**PROPOSED DISPOSITION OF BALLOT
COMMENTS ON**

IEEE P802.1ad/D2

**Virtual Bridged Local Area Networks
— Amendment 4: Provider Bridges**

**Proposed Disposition of Ballot Comments prepared by:
Mick Seaman, Project Editor**

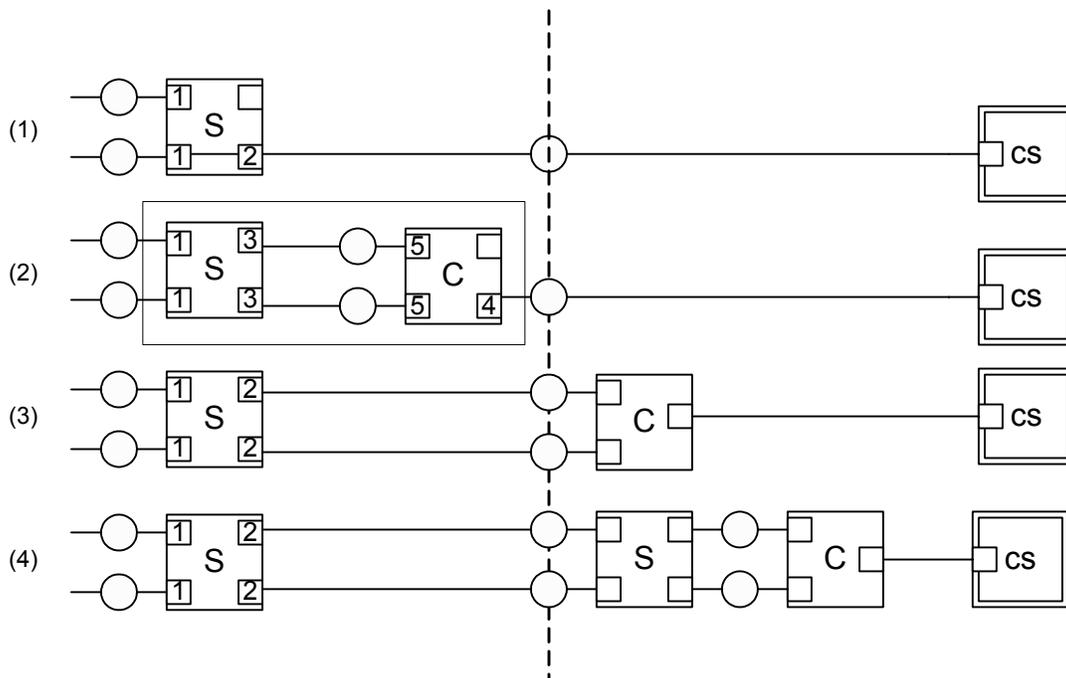
- * network ports
- * edge ports (in case of using a C-VLAN aware component port at the edge)
- * selecting edge ports
- * translating edge ports

Internally the provider bridge may have:

- * selecting network port

- * network port
- The 4 external visible interface should be described in section 15.
- * selecting edge port: port based
- * edge port: customer tagged service interface
- * translating edge port: provider tagged service interface

COMMENT END:
SUGGESTED CHANGES START:
Change naming as suggested
SUGGESTED CHANGES END:

The above distinctions are quite independent as to whether a given provider decides that any of the ports labelled '2' will not provide service, because the customer should not S-tag frames. Whether the customer should or not, frames will have to be screened. So further configuration of the ports shown may perform further service instance selection, screening, and VID renumbering tricks, but as Arjan points out these functions are somewhat orthogonal. Further scenario (2) shows that screening (at ports '3') to ensure only the right traffic is admitted to a service instance, isn't necessarily a function of the first provider owned port (4) that customer traffic ingressing to the network encounters. So we could introduce more names to further reflect how ports are configured but I fear they would only result in a '2a', '2b' sort of distinction. The above labels being chosen to reflect the minimum necessary for correct service instance selection and segregation, not all things that might be desirable in a service offering.
